TOWN OF PLAINFIELD DESIGN REVIEW COMMITTEE

DATE: 12-09-2025
Project Page: [Crew Car Wash - West](#)
CASE NO.: PUD-25-XXX
 PP-25-XXX
 FDP-25-XXX
PETITIONER: Katherine Rayner, Crew Carwash
REQUESTED ACTIONS: Amendment to Legacy Farms Planned Unit Development to add land; Architectural and Site Design Review for a proposed car wash; Amendment to existing Primary Plat
LOCATION: Ventura Boulevard at West Main Street
PARCEL SIZE: 3.74 acres +/-

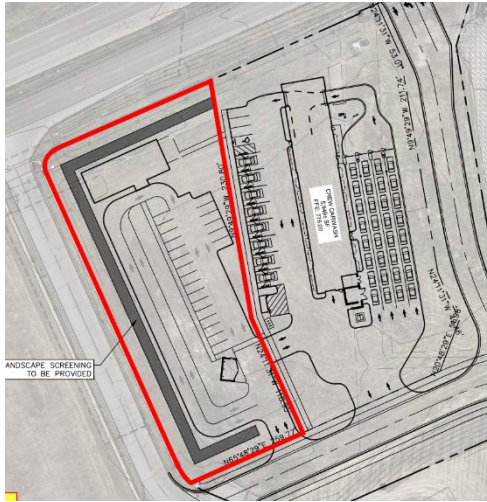
Staff observed jet dryer noise from the Crew Carwash location on East Main Street while standing in Hobbs Station, over 900 feet away, through a considerable tree line. This distance is

shown in the graphic to the left. While the applicant has proposed an enhanced landscape buffer, landscaping alone is not expected to mitigate the sound generated by the drying equipment to an acceptable level for nearby homes. Nationally, carwash air-drying systems are documented to generate significant decibel levels, and the Town's preference for a parallel orientation of the building was intended in part to reduce this impact.

For these reasons, Staff recommends revisiting the building orientation to better adhere to Town planning practices and to address potential adverse impacts on the adjacent residential community.
